**From:** Branch Smith <bsmith@paramounte-eng.com>  
**Sent:** Monday, September 26, 2016 10:24 AM  
**To:** Chao, Ming-tai  
**Subject:** RE: Everett's LCIDLF, P1303, DIN 26720  
**Attachments:** 160926 LCID-2.pdf

**From:** Chao, Ming-tai [mailto:ming.chao@ncdenr.gov]  
**Sent:** Friday, September 09, 2016 2:07 PM  
**To:** Branch Smith <bsmith@paramounte-eng.com>  
**Cc:** Hare, Wes <wes.hare@ncdenr.gov>; lynn@ecandg.com  
**Subject:** Everett's LCIDLF, P1303, DIN 26720

The Solid Waste Section (SWS) completed a review of the revised Permit Application (DIN 26704) and has two comments stated below:

**LCID-2**

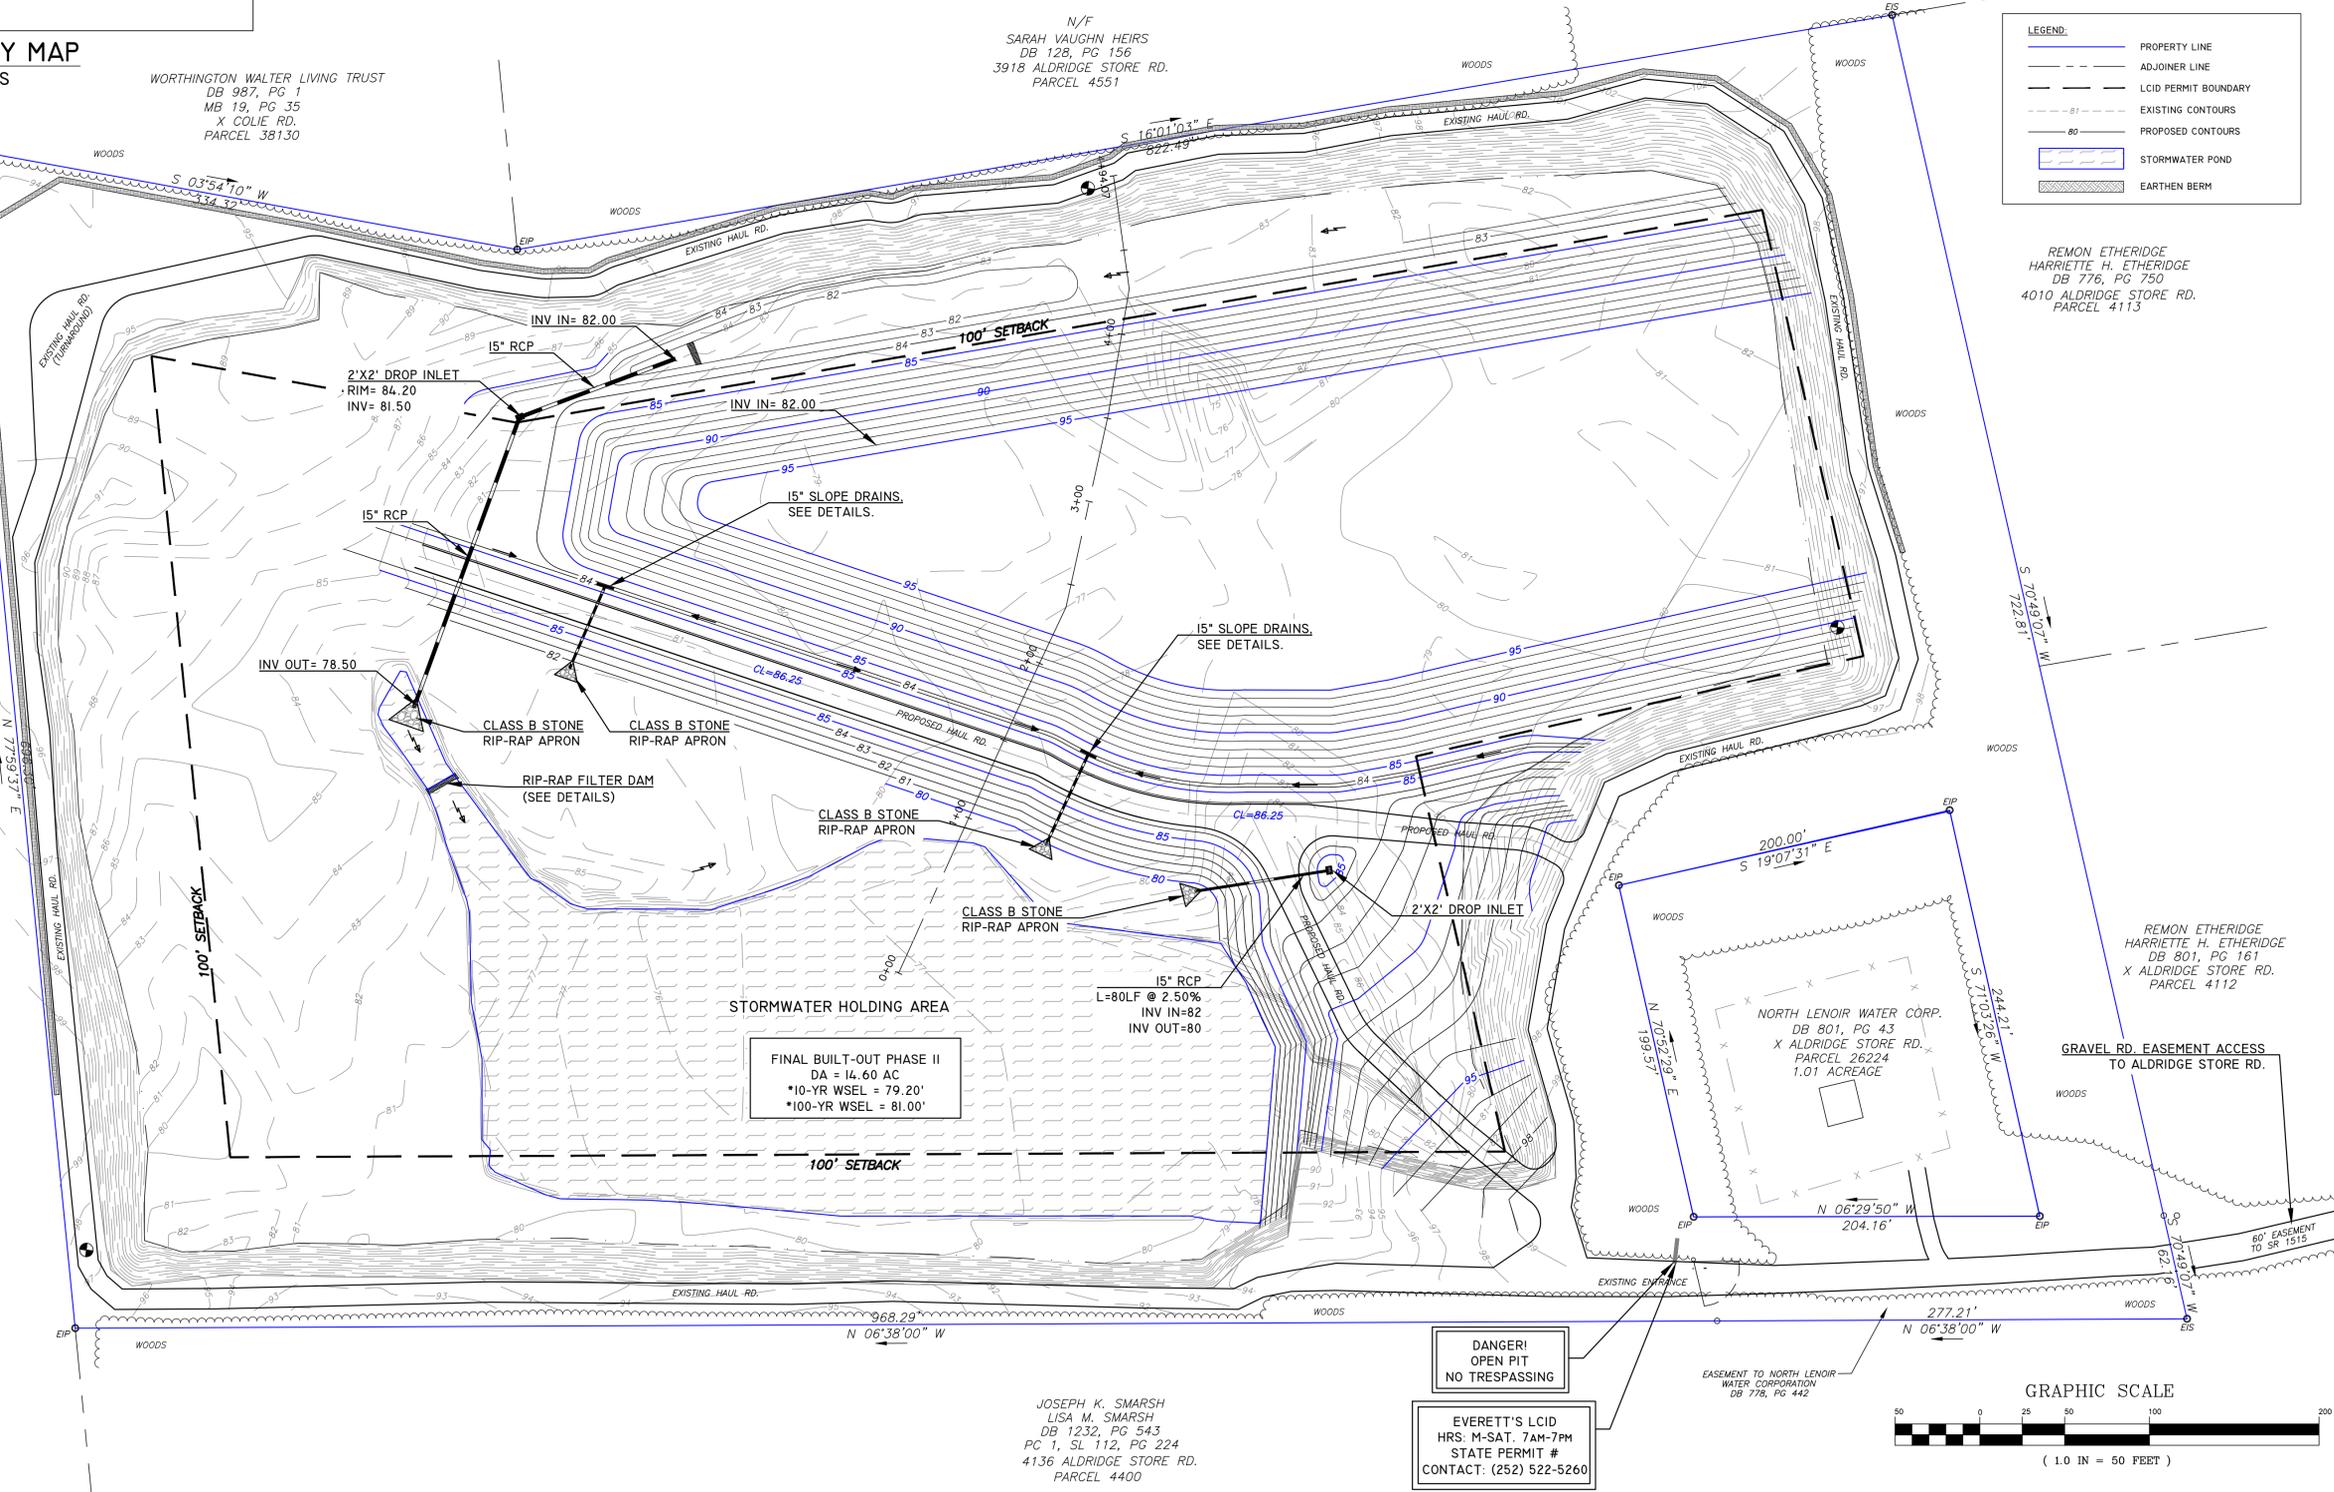
Please review the map and see if this approach will meet the concerns of leachate draining into potentially damaged pipe. I propose concrete pipe sealed watertight. The other option is digging a ditch but any leachate will get in this ditch as well. This pipe is not directly under the landfill as it is in clean fill. Runoff and leachate will always be of concern, but this should minimize your concerns as stated below.

**Response: O&M text changed.**
2. (Drawing Nos. LCID-2 & LCID-3) A 24-inch-diameter aluminum pipe is added to the revised plan drawings to drain the surface runoff in the ditch along the east side of the landfill into the stormwater holding area, which is located on the west side of the landfill. And this transverse aluminum pipe is to be installed underneath the landfill. The SWS has strong concerns of this design because the buried pipe, if it is damaged or leaks for any reason, will potentially provide a least-resistant path for leachate migration to the on-site surface-water body (stormwater holding area) and consequently to the groundwater underneath the landfill. (Don't forget what causes the coal ash spill into the Dan River.) Leachate is defined as any liquid, including any suspended components in liquid, that has percolated through or drained from solid waste according to Rule 15A NCAC 13B .0101(24). Please noted that the landfill will be perpetually located at the property, but the pipe has a limited service

life. Mr. Everett who owns and operates this landfill will be legally and financially responsible for any environment damages to surface water and groundwater resulting from leachate migration via the damaged pipe. Consequently, this design has a potential violation of the Rule 15A NCAC 13B.0566(14) - leachate shall be properly managed on site through the use of current best management practices.

**Response: Pipes have been removed – see revised maps.**
